N6773A-01

S E R V I C E N O T E

N6773A 300W DC Power Module

Location of C36 and C37

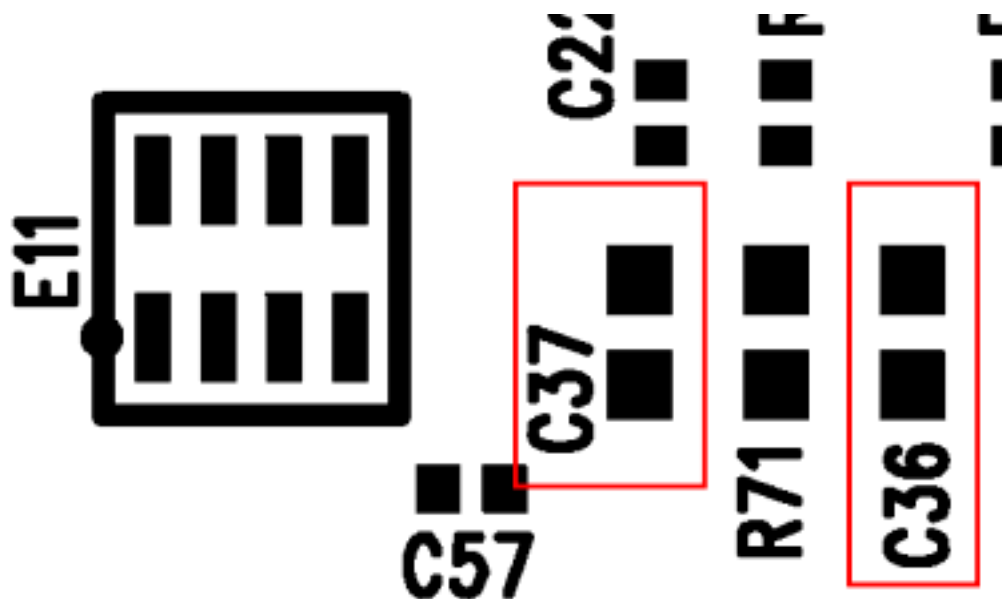
Due to some noise filtering issues, the current measurement accuracy will be out of specification by a fixed offset when there is a voltage being sourced at the output terminals. If the output is shorted, the current measurement accuracy will be within specifications. Please note that the performance verification test will not catch this.

If this measurement is out of specification, replace capacitors C36 and C37 on the DPM assembly (this is the assembly that is vertically mounted in the unit that looks similar to a PC memory module) with part number 0160-7809. After the capacitors are changed, the unit will require re-calibration. After the capacitors are replaced, check the make sure that the unit is in specification by applying 75% of the full voltage range while attached to a load drawing 50 mA to 70 mA. If the current measurement is within the specification, then the unit has been repaired.

Test to see if the module is out of specification by applying 75% of full scale voltage while drawing 50 to 70 mA . Compare the reading to what it should be via the current measurement accuracy spec. If the current measurement is within specification then the capacitors will not need to be changed.
